# City of North Miami Beach, Florida

### PLANNING & ZONING BOARD

File No: 21-9

Project Name: 168 Professional Office Building

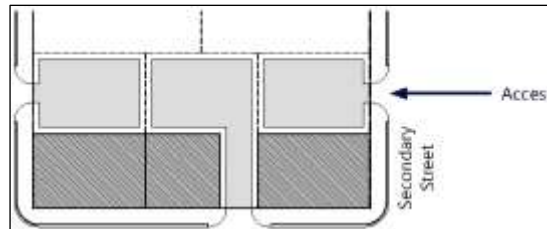
The project meets the required minimum of 37 spaces by providing 38 parking spaces.

- Eighteen (18) of the provided thirty-eight (38) spaces are regular 9 x 18 feet parking spaces. One of the eighteen (18) spaces includes an electric charging station. An additional eighteen (18) spaces will operate as mechanical car lifts. Two (2) of the provided 38 spaces are 12 x 20 feet ADA parking stalls.
  - Proposed mechanical lifts are provided by Parkmatic Car Parking Systems. The owner/Employer shall ensure that lift operators are qualified and that they are trained in the safe use and operation of the lift using the manufacturer's operating instructions.

### **Loading Zone Requirements**

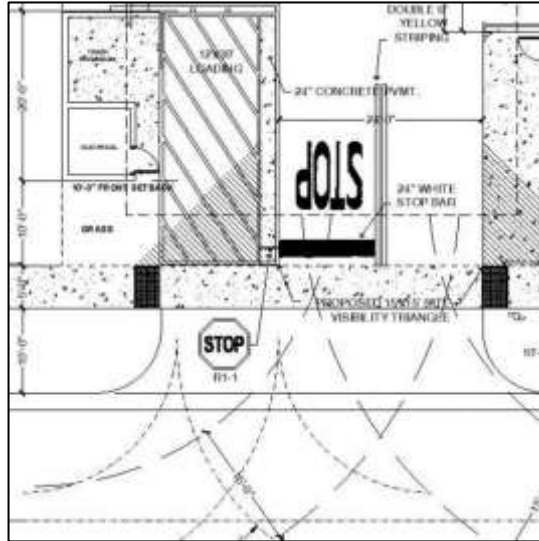
- **(B) Space Dimensions.** An off-street loading space shall include an area of at least twelve (12) feet wide by thirty (30) feet long with fourteen and one-half (14½) feet vertical clearance. The plans indicate that the ground floor has a ceiling height of 14 feet and 6 inches. Each off-street loading space shall be easily accessible and arranged for convenient and safe ingress and egress by motor truck or trailer combination. Pursuant to Section 24-97. An office space between 5,000 – 20,000 square feet only requires one loading zone.

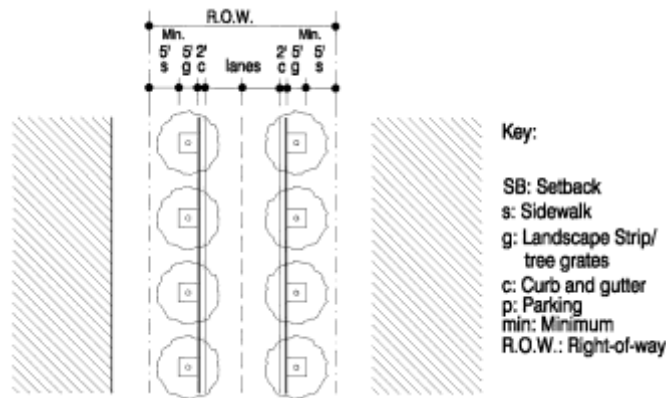
The applicant has provided adequate canopy replacement for the proposed site. However, the applicant must update minor discrepancies in his landscape plans and shows that they reflect the mixed-use regulations. The landscape plans portrayed in the photometric is Mixed-Use compliant, but the landscape plans are not. The landscape plans display 8 Montgomery Palms, 1 Florida Royal Palm, and 3 Mahogany Trees. According to Mixed Use regulations a maximum of twenty-five (25%) percent of all required trees shall be of a palm species. This project exceeds the max percentage of Palm Trees in the mixed-use district. A note has been added to the report requiring the applicant to provide an update landscape plan demonstrating compliance with the code prior to City Commission review.

- The provided sheet shows the removal of all existing trees on site. These trees consist of two avocado and two mango trees. The proposed trees listed I sheet L-1 provides a canopy replacement that exceeds the square footage of what was removed.
  - Applicant must correct plans and modify his streetscape design to be in accordance with MU-58(J)(3)(c)(iv) all streets and alleys shall be designed according to the typical street sections and must comply with figure MU-3:
